**MODIFICATIONS TO
CONTRACT EROSION PREVENTION
AND
SEDIMENT CONTROL (EPSC) PLAN**

RANDOLPH BRO 1444 (57)

J.P. Sicard, Inc.
PO BOX 508
Barton, VT 05822

EPSC NARRATIVE AMENDED

EPSC 1
Sheet of -

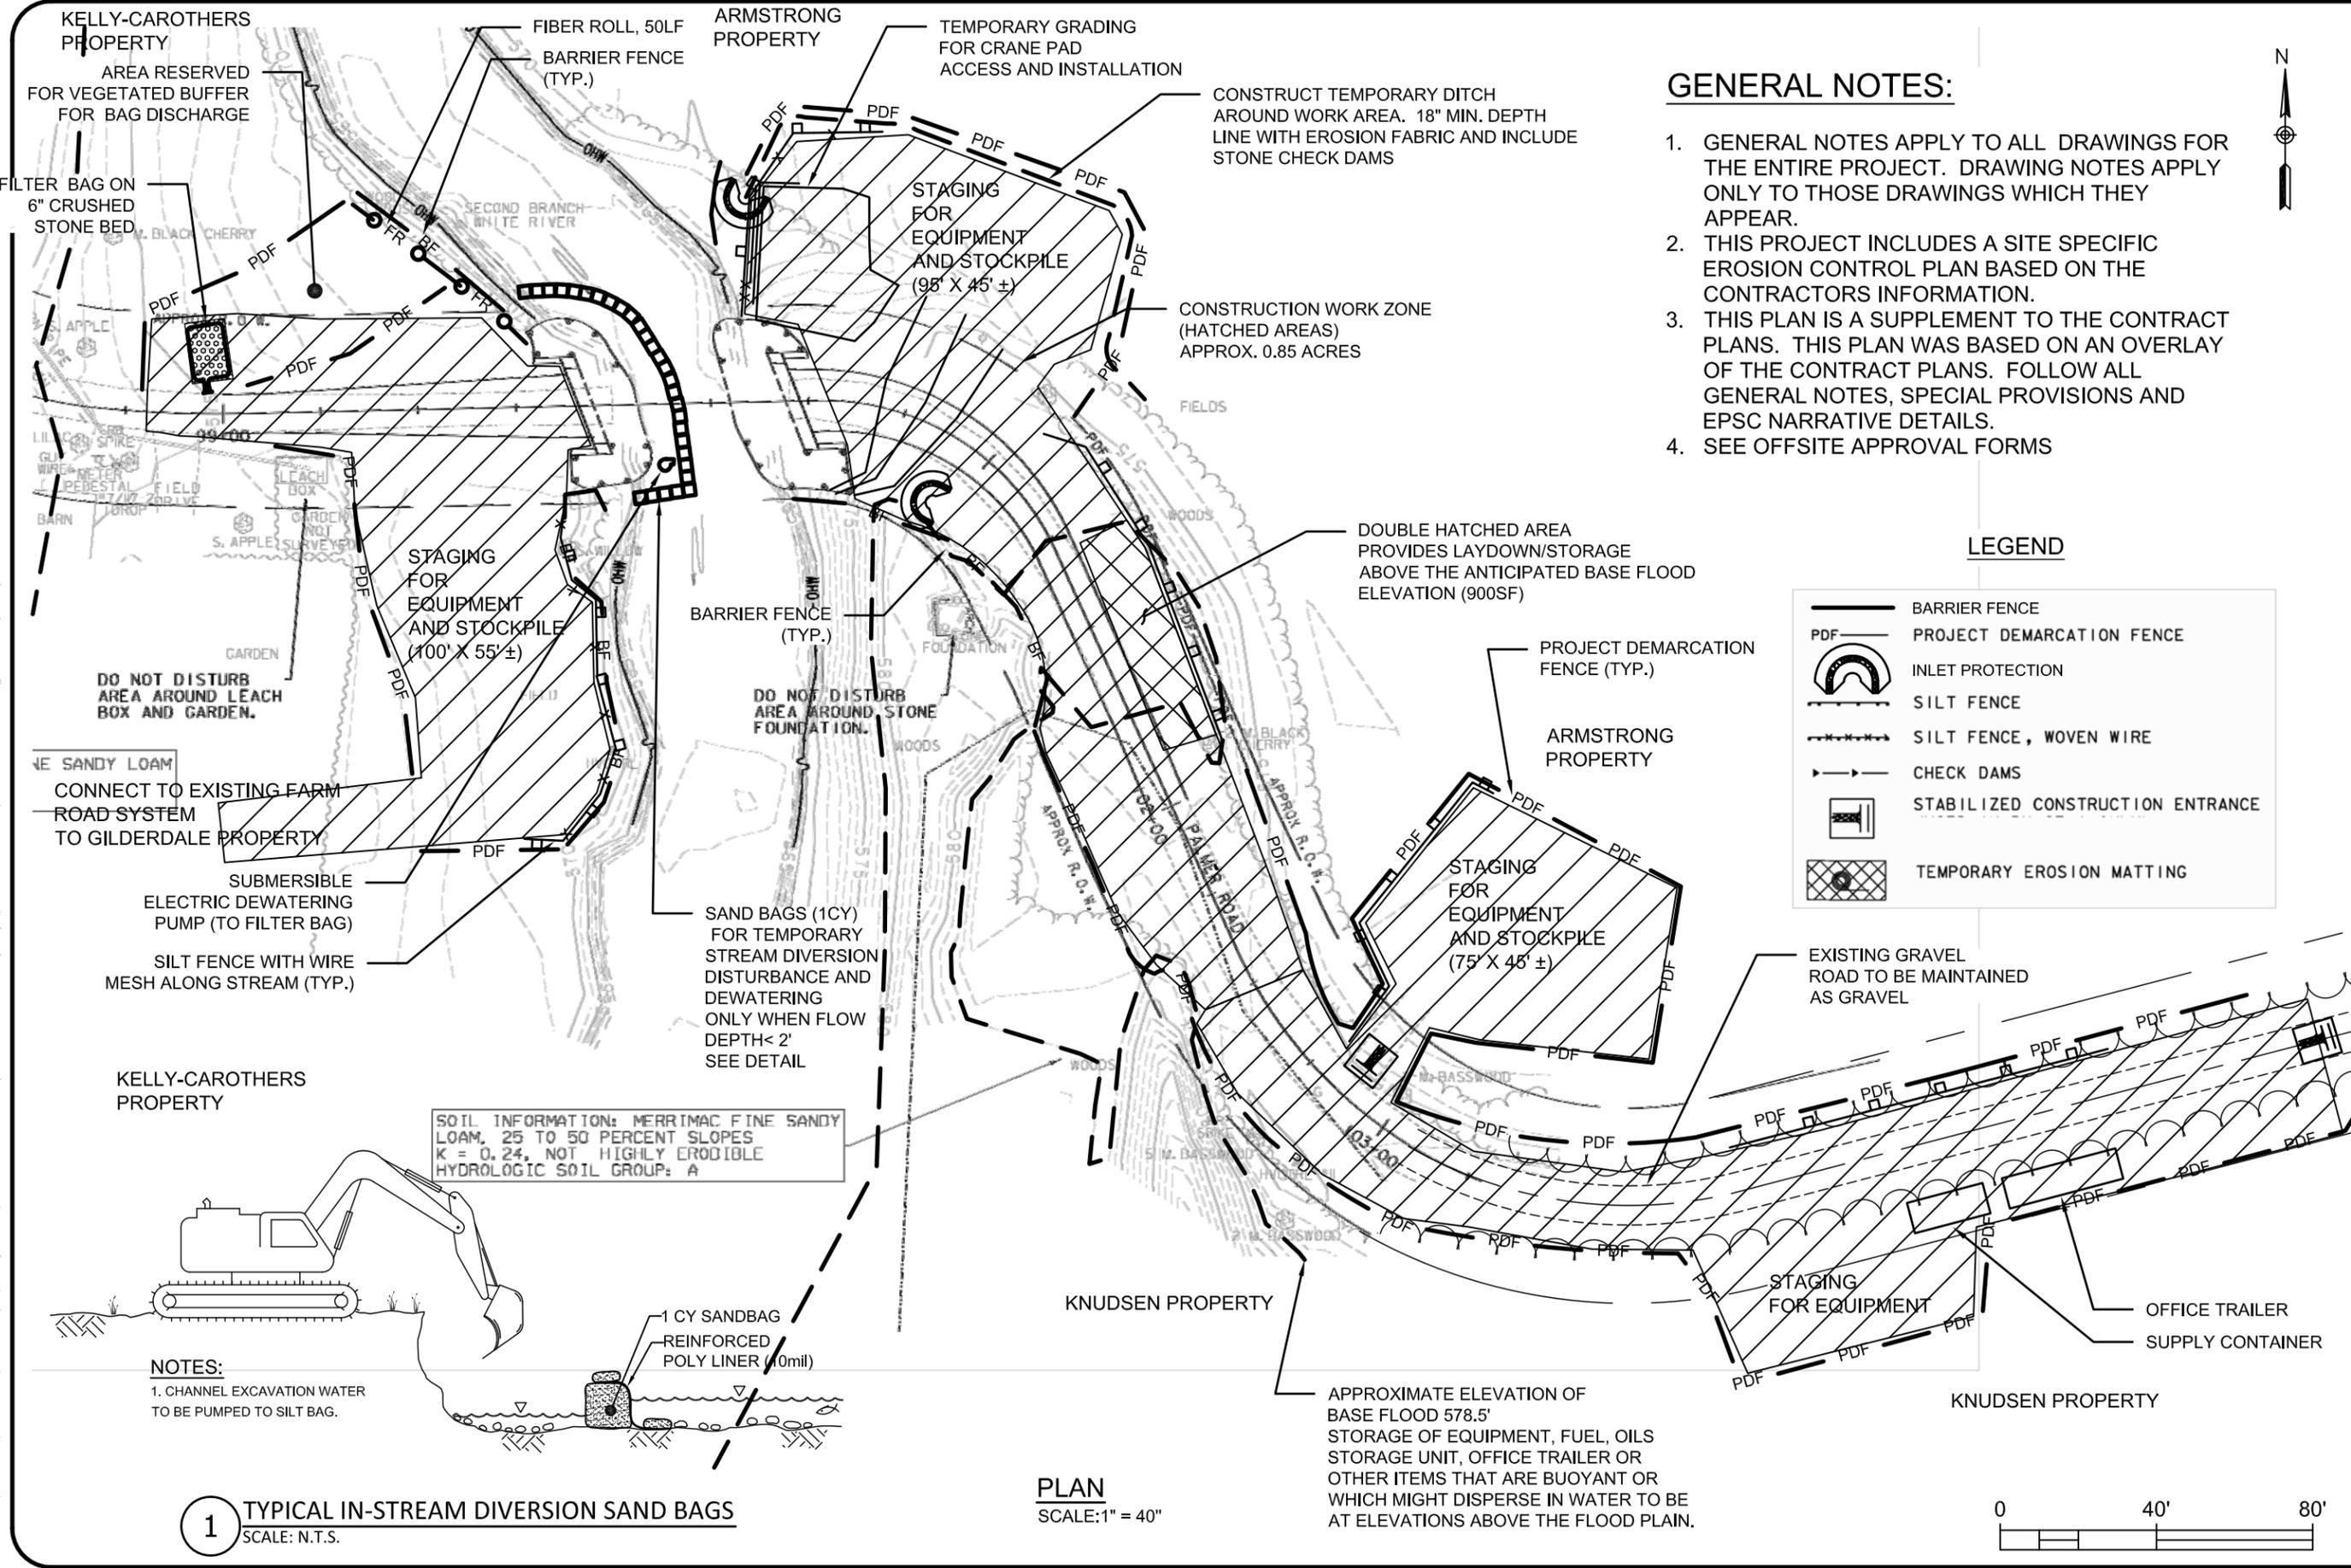
REVISIONS	No.	Description	Date
	1	ADD OFFSITE ACTIVITY DISTURBANCE AREAS	3/31/15

EPSC2
Sheet of -

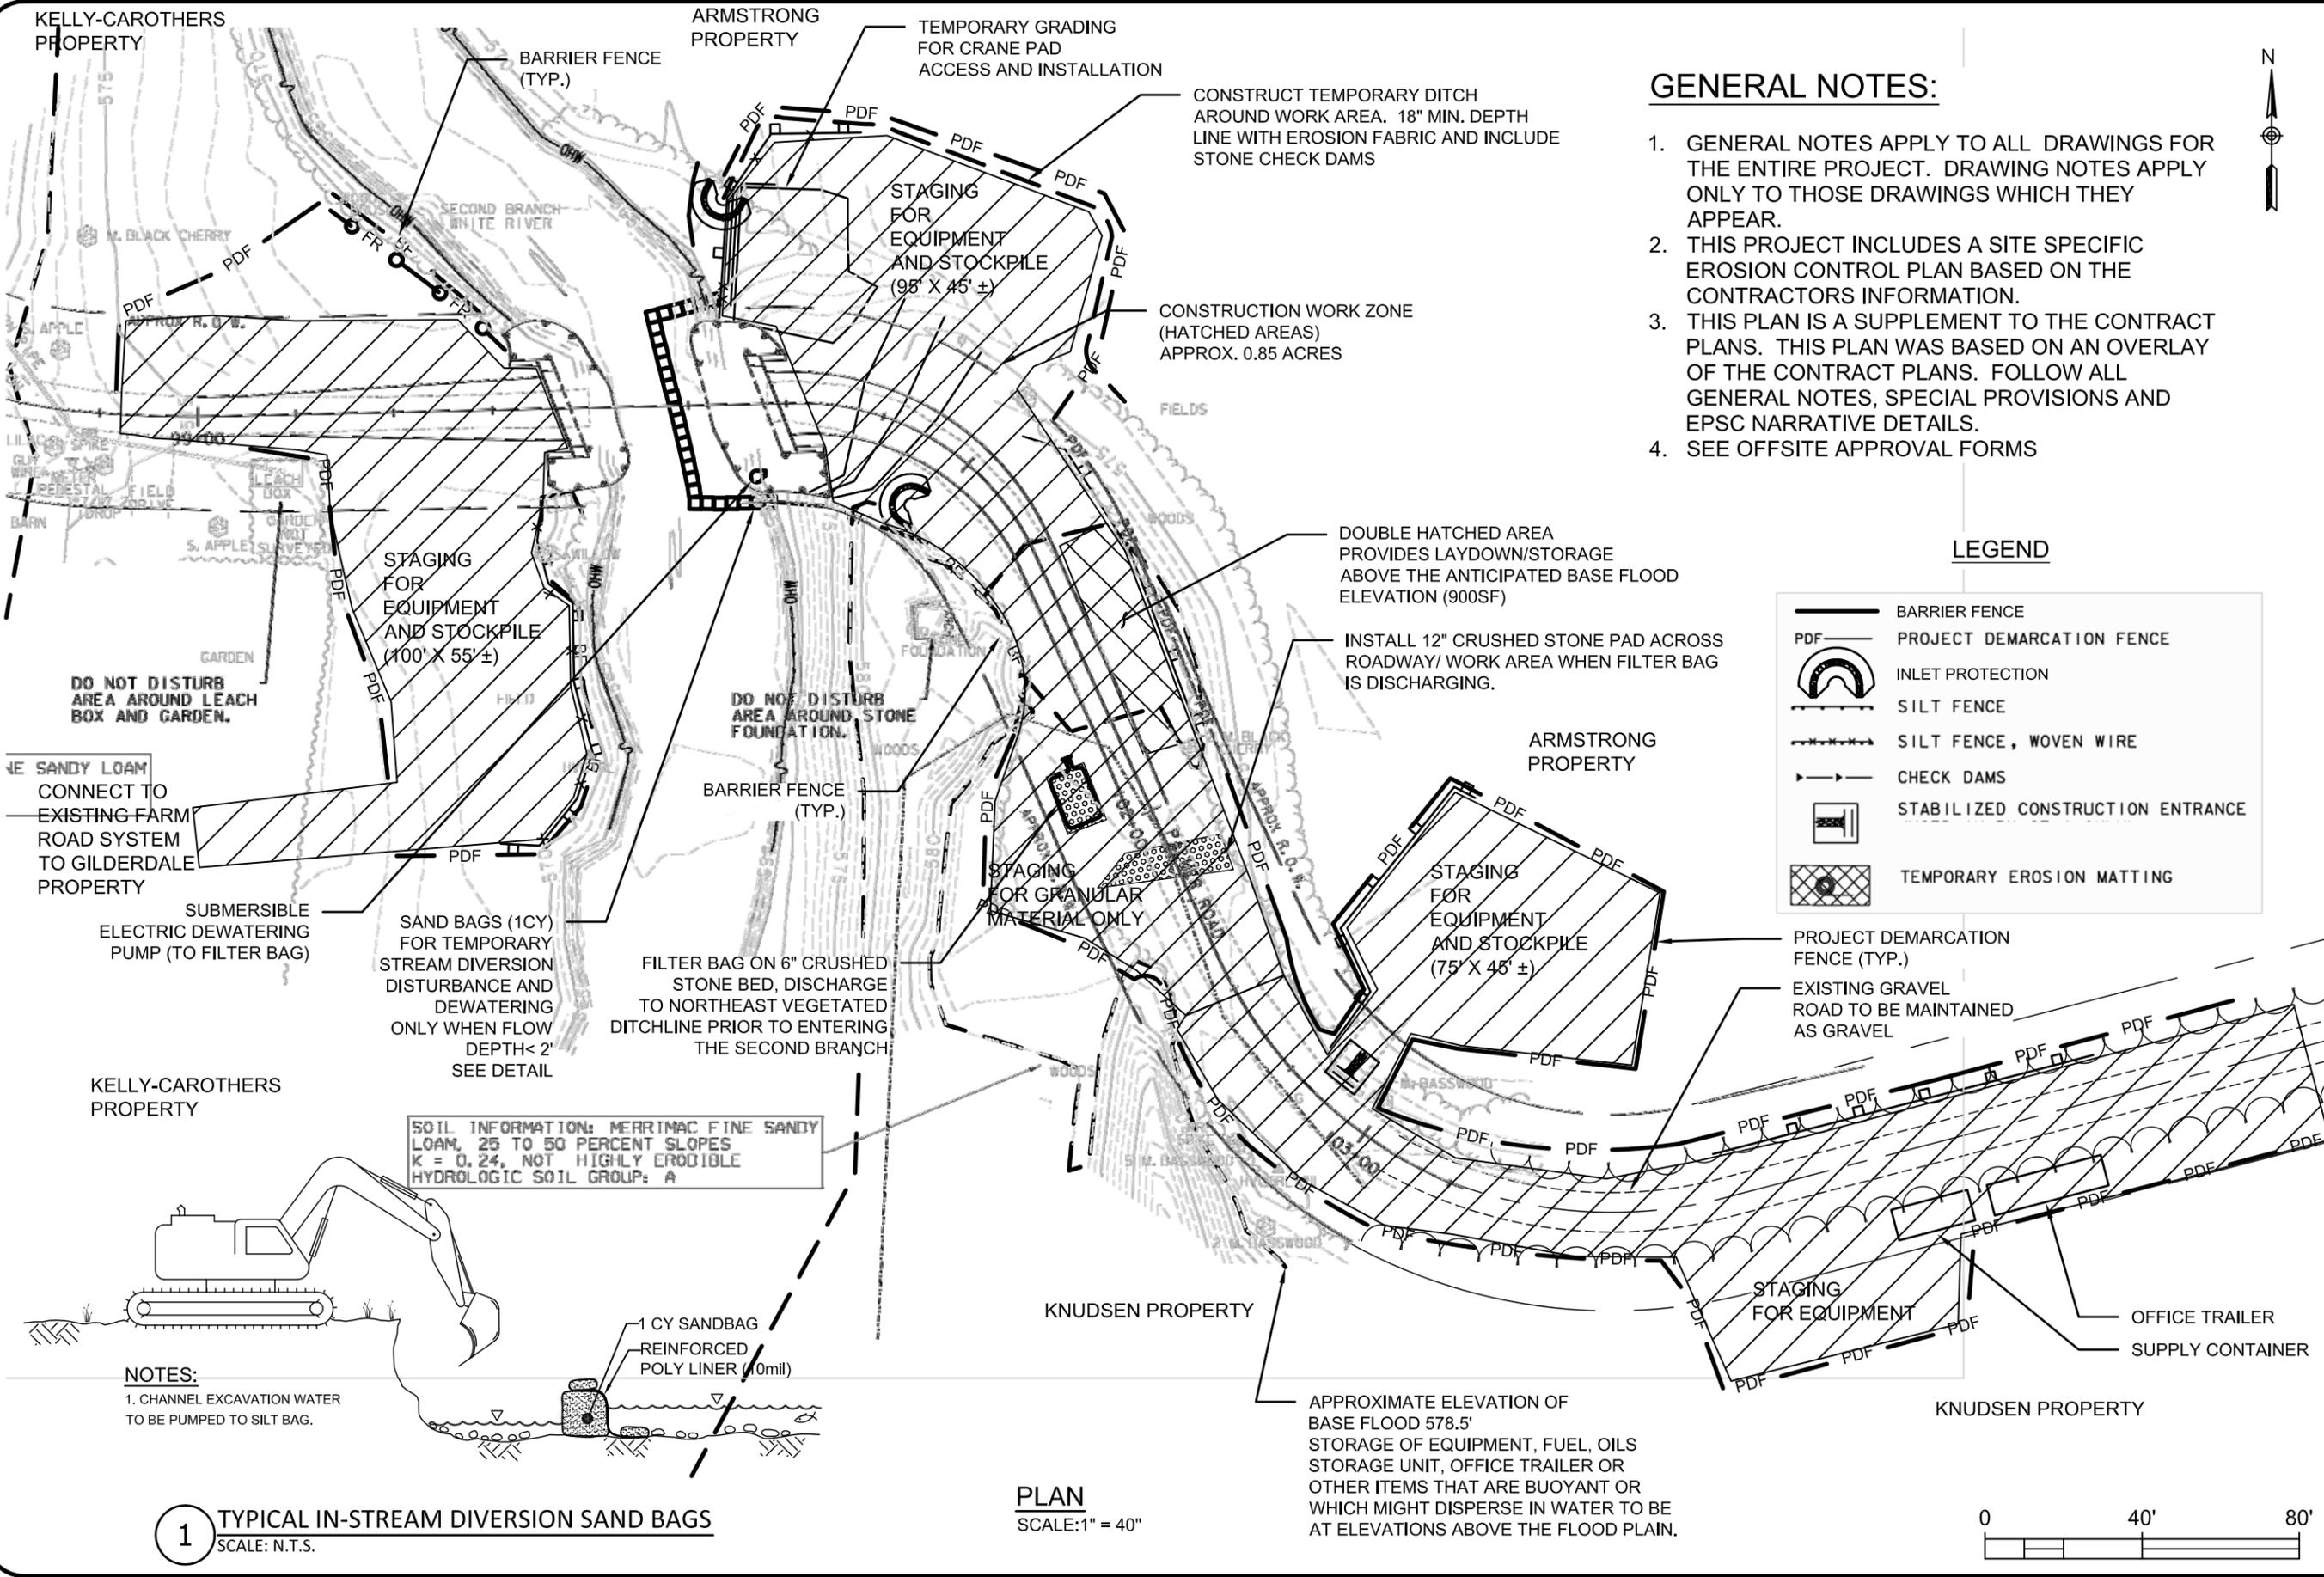
REVISIONS	No.	Description	Date
	1	ADD OFFSITE ACTIVITY/DISTURBANCE AREAS	3/31/15

PHASE III SITE SPECIFIC EROSION CONTROL PLAN
RANDOLPH BRO 1444(57)

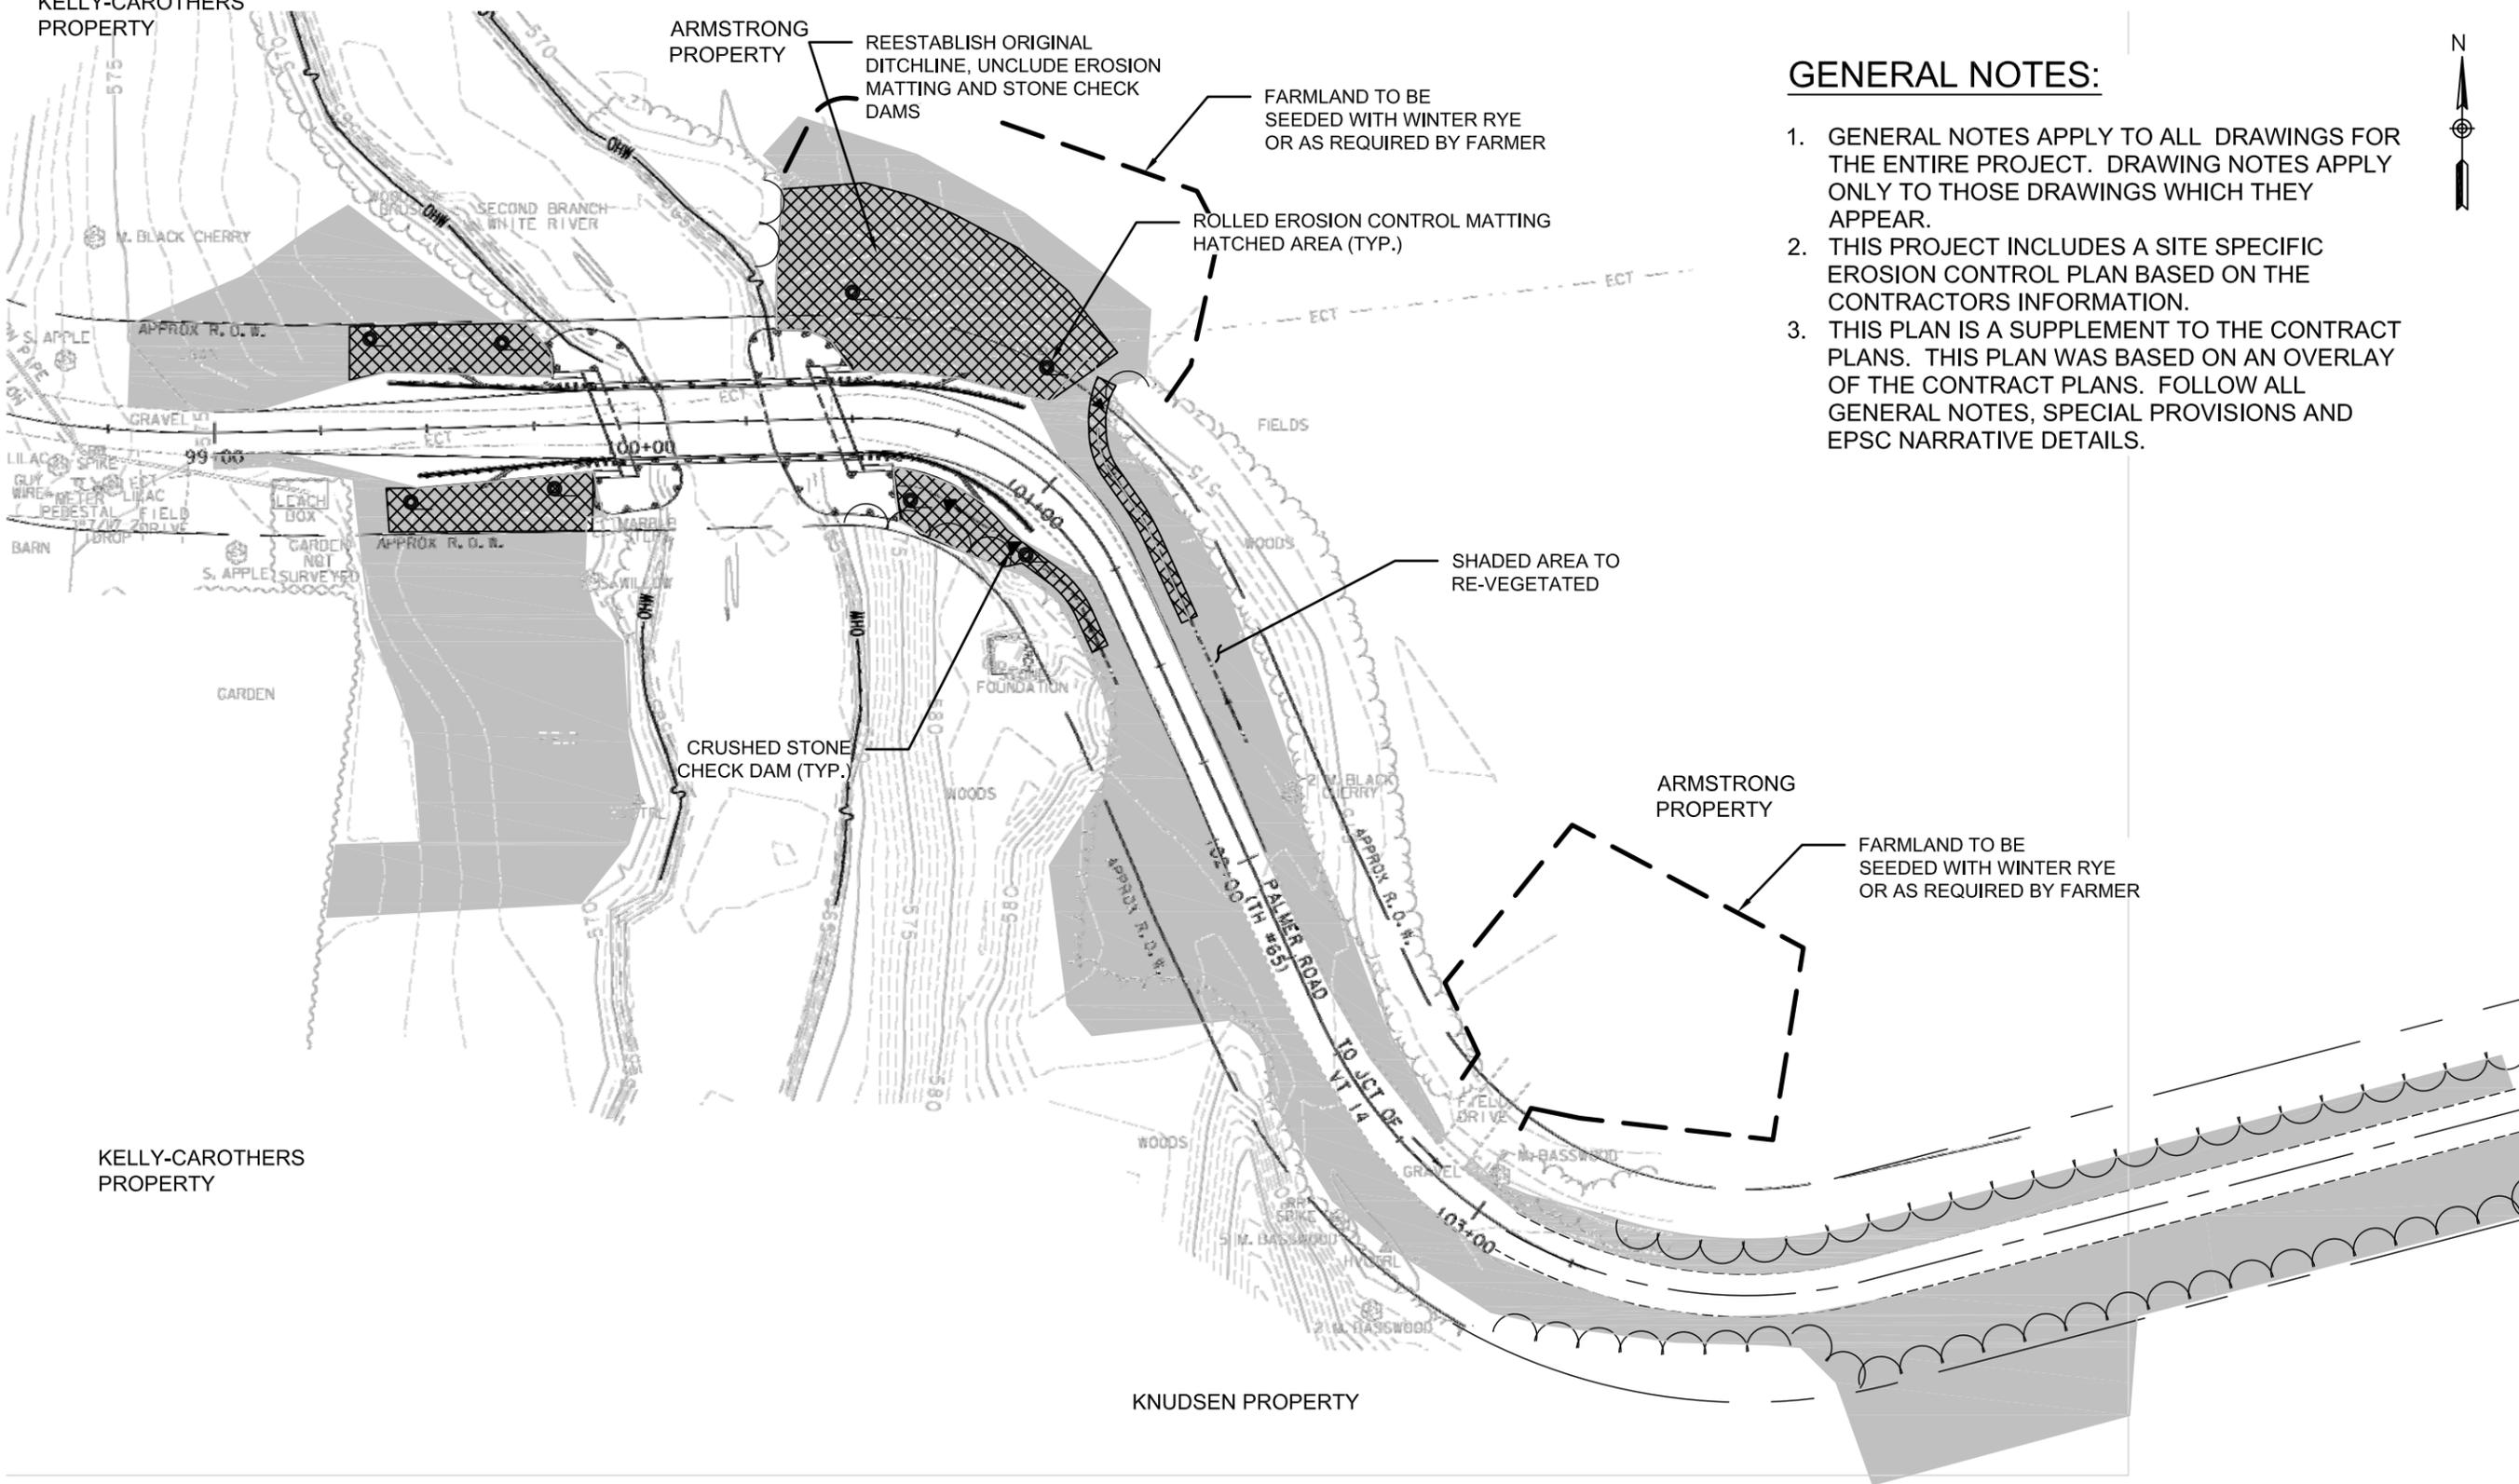
REVISIONS	No.	Description	Date
	1	ADD OFFSITE ACTIVITY DISTURBANCE	3/31/15
